LINDSTRAND BALLOONS LTD

SERVICE BULLETIN NO. 4

ISSUE 2 - DATED 12.03.98

<u>Title:</u>	MULTI-BURNER GIMBAL BLOCK
<u>Classification:</u>	Recommended
<u>Applicability:</u>	Jetstream Double + CLF, Jetstream Triple, Jetstream Triple + CLF, Jetstream Quad Burners.
<u>Serial Numbers Affected:</u>	019, 018, 028, 041, 070, 066, W/O 1129/1130, 165, 082, 101, 090, 074, 094, 090, 100, 135, 095, 188, 171, 190, 197, w/o 1808, 200, 249, 250, 297, 298, 307, w/o 3312, 311 312, 325, 235, 326, 334, 336, 300, 335, 345, 350, 358, w/o 3711, 377, 372, 378, 387, w/o 3724, 391, 326, 304, 409, 412, 413, w/o 14314, 421,317, 427, 431, 439, 445, 446, 447.
<u>Compliance Standard:</u>	Inspection to be achieved within the next 10 hours flying time.
<u>Background:</u>	The gimbal block shown in Fig SB4-001 and used on all the above burner types is designed to allow variable friction, independently on each gimbal axes by adjustment of four socket head cap screws on each axes. In one installation, sufficient friction could not be achieved due to the two faces of the block meeting. Subsequent adjustment of the four cap screws or weakening of the central block section has caused thread failure within the central blo

FIG SB4-002. ORIENTATION OF GIMBAL BLOCK

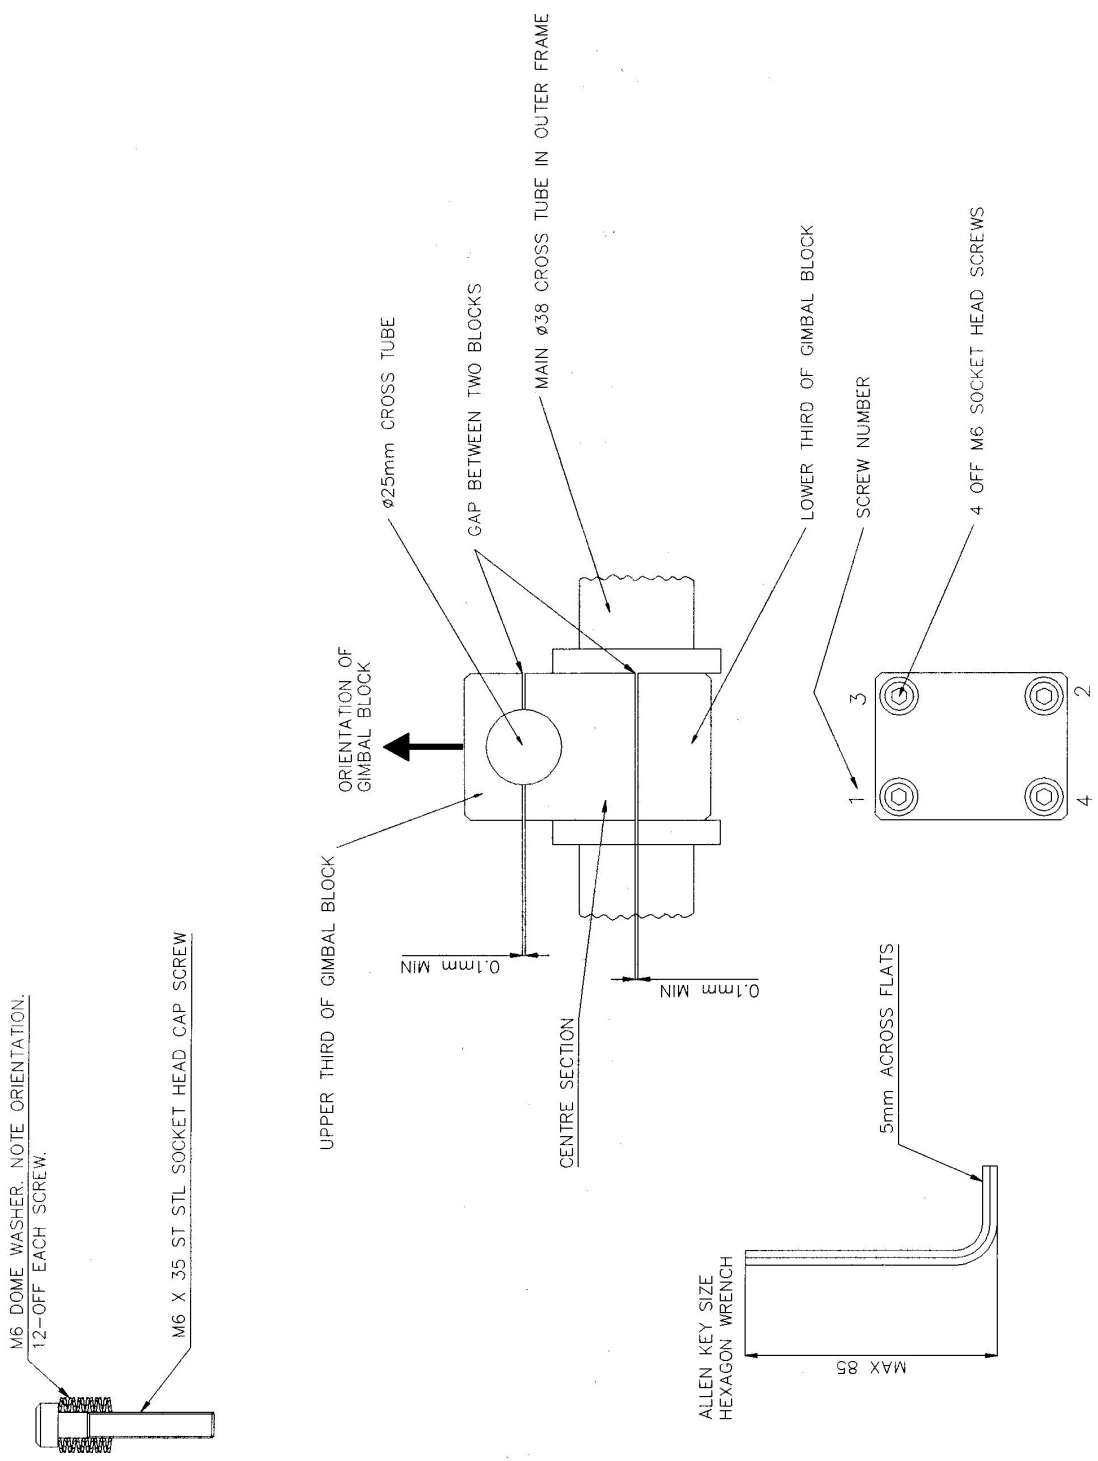
Both sides of the same gap should be equal and not less than those specified on Figure SB4-002. If the gaps are not equal, implement the procedure below.

If both sides of either gap are equal and less than those specified on Figure SB4-002, then a new gimbal assembly must be fitted. In this case, contact Lindstrand Balloons Ltd immediately.

If both sides of each gap are equal and greater than those specified on Figure SB4-002, then implement the following procedure:

1. Identify the screws securing the gimbal end cap to the centre section about the 25 mm cross tube.
2. Referring to Figure SB4-002:

Remove screw no. 1 using a 5 mm across flats Allen key (hexagon wrench), no bigger than that shown on the figure.

3. Apply Loctite 222 thread adhesive sparingly to the screw thread between 3 mm and 6 mm from the threaded end.
4. Ensure that the dome washers are assembled within the counter-bored hole of the gimbal block end cap, or over the screw, in the order shown on the figure.
5. Replace the screw in the hole and re-tighten using the allen key, until the screw is just nipped up.
6. Remove screw no. 2 using the allen key and repeat steps 3 through 5 inclusive.
7. Remove screw no. 3 using the allen key and repeat steps 3 through 5 inclusive.
8. Remove screw no. 4 using the allen key and repeat steps 3 through 5 inclusive.

9. Using the allen key, turn screw no. 1 a quarter turn. Repeat for screws no. 2, no. 3 and no. 4 in that order. Check the gimbal stiffness. Ensure that the screws are tightened in the above sequence and that both sides of the gap between the upper third of the gimbal and the gimbal centre section remain equal.

Each side of the gap between the upper third of the gimbal block and the gimbal centre section should be equal and greater than the dimension specified on Figure SB4-002. Similarly, each side of the gap between the lower third of the gimbal block and the gimbal centre section should be equal and greater than the dimension specified on Figure SB4-002.

If after measurement, either of the gaps are less than those specified on Figure SB4-002, then a new gimbal assembly must be fitted. In this case, contact Lindstrand Balloons Ltd immediately.
